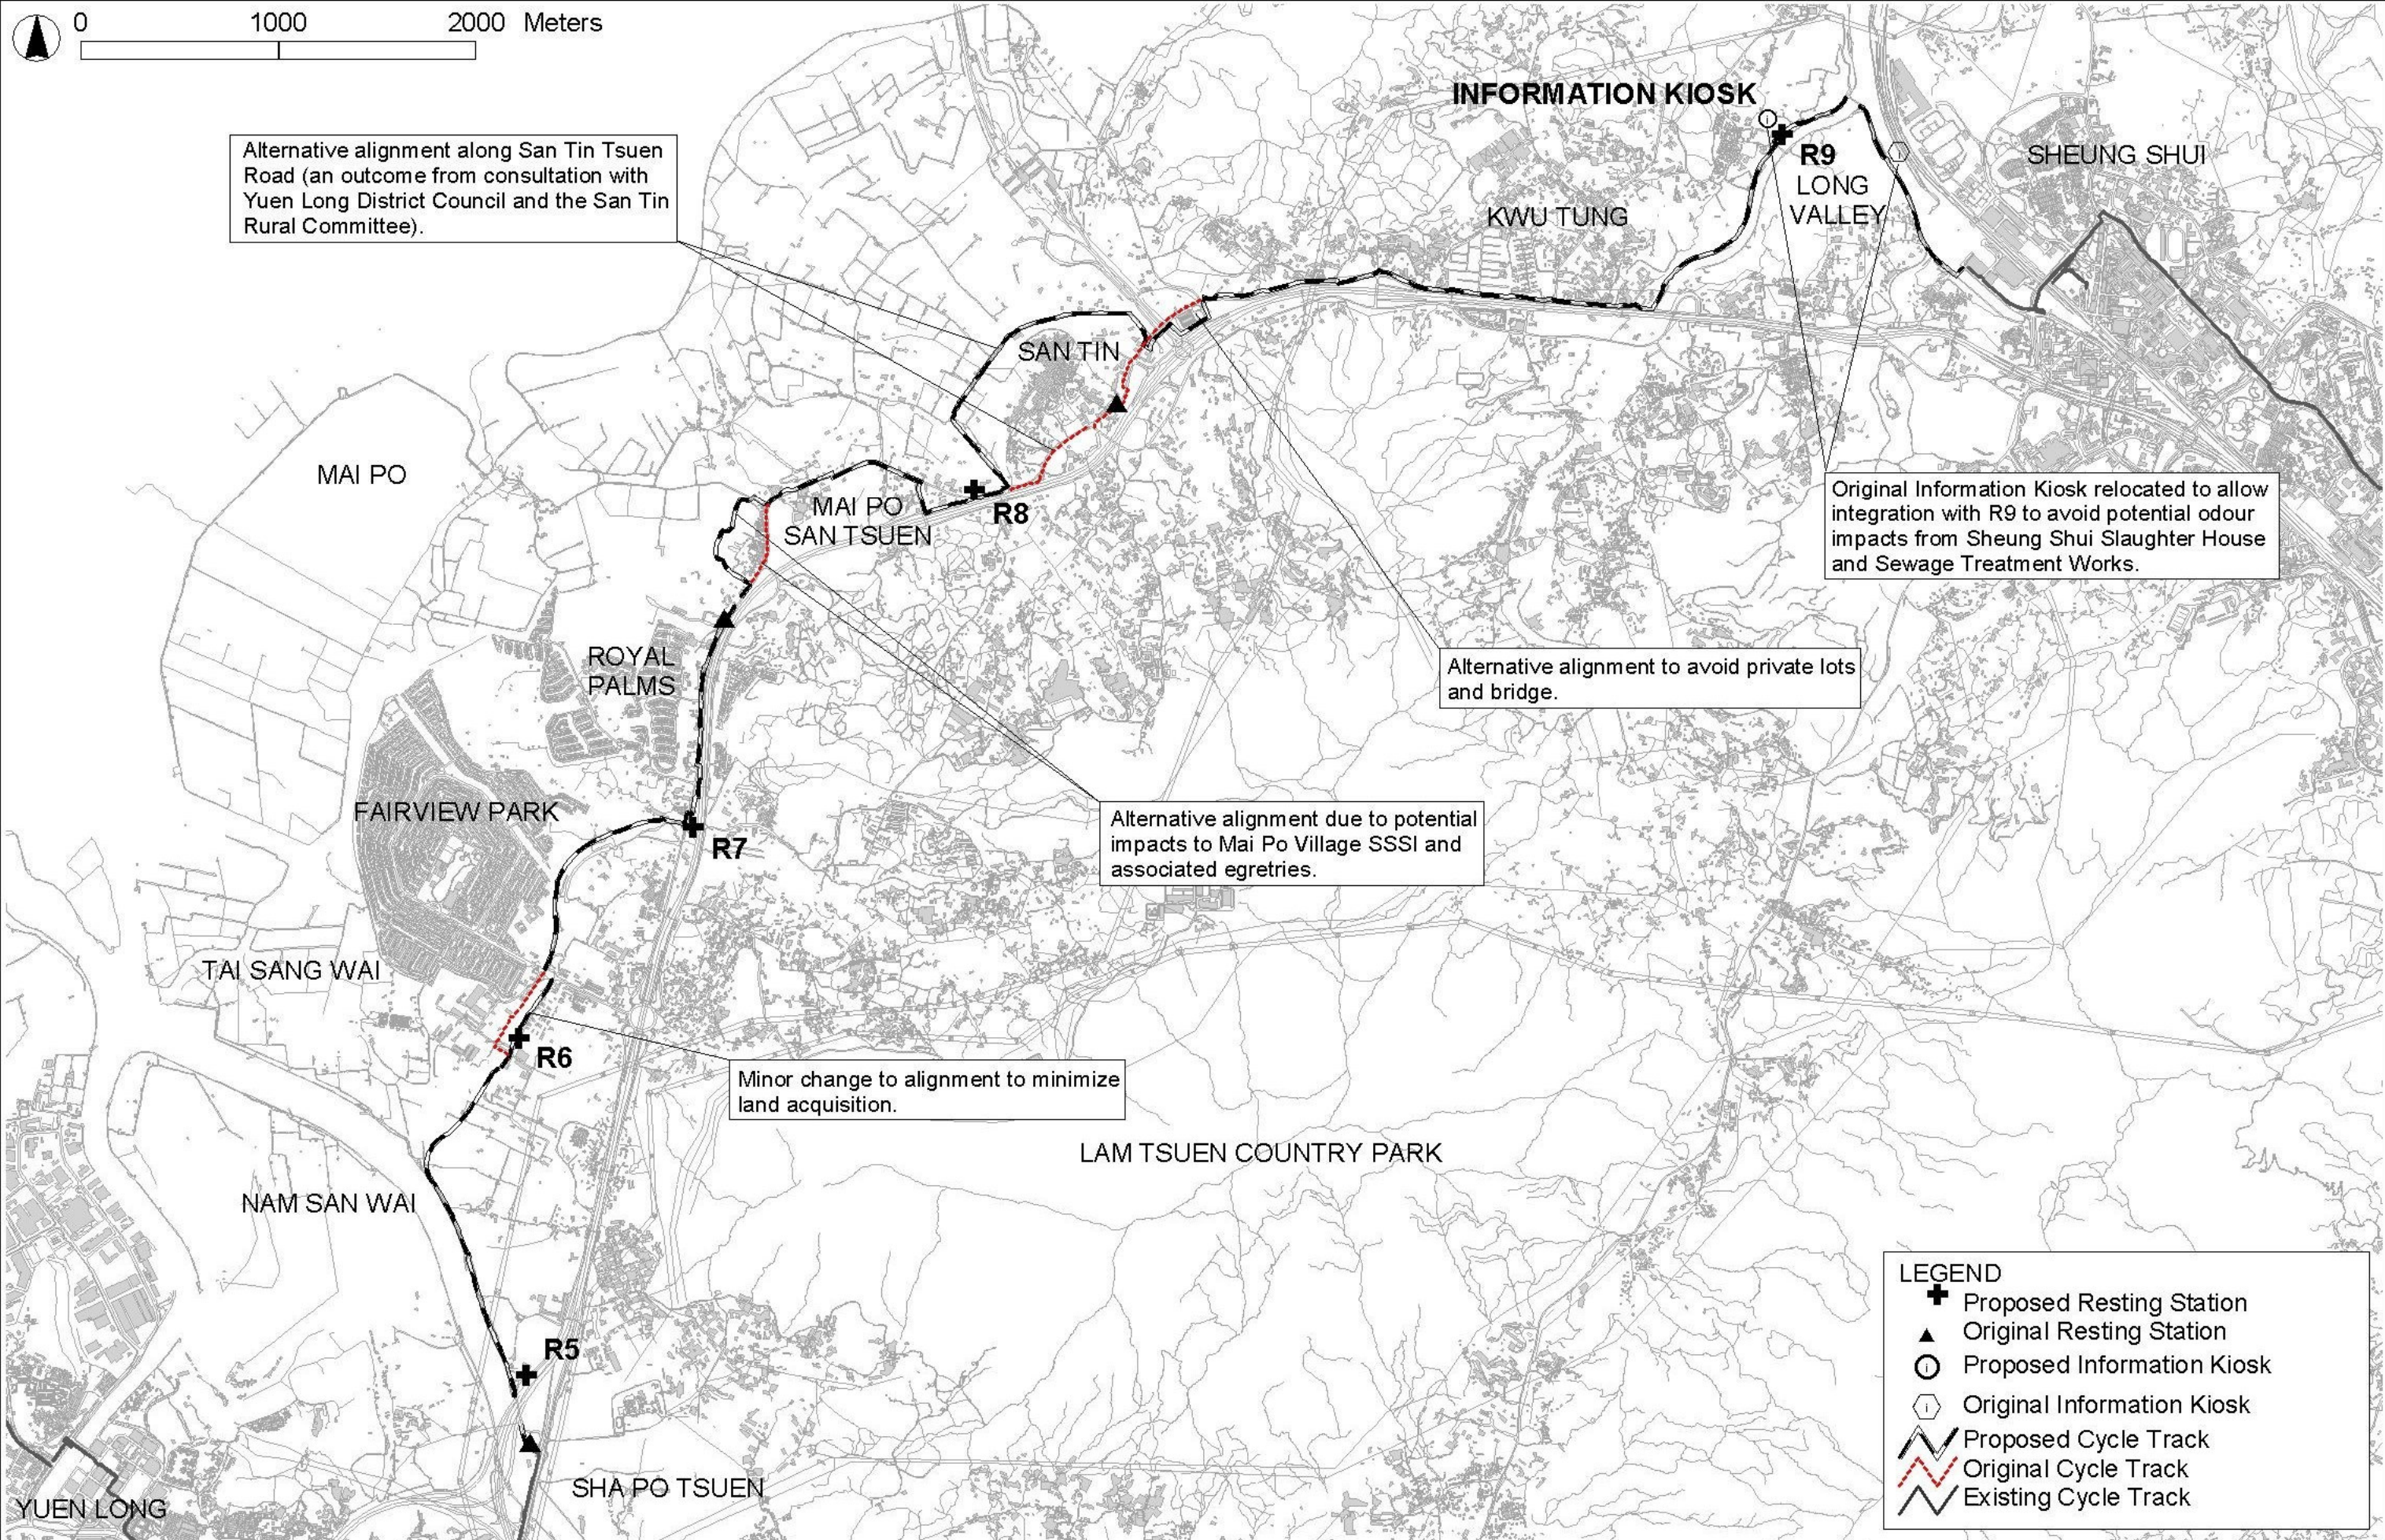
Alternative alignment along San Tin Tsuen Road (an outcome from consultation with Yuen Long District Council and the San Tin Rural Committee).

Original Information Kiosk relocated to allow integration with R9 to avoid potential odour impacts from Sheung Shui Slaughter House and Sewage Treatment Works.

Alternative alignment to avoid private lots and bridge.

Alternative alignment due to potential impacts to Mai Po Village SSSI and associated egrettries.

Minor change to alignment to minimize land acquisition.
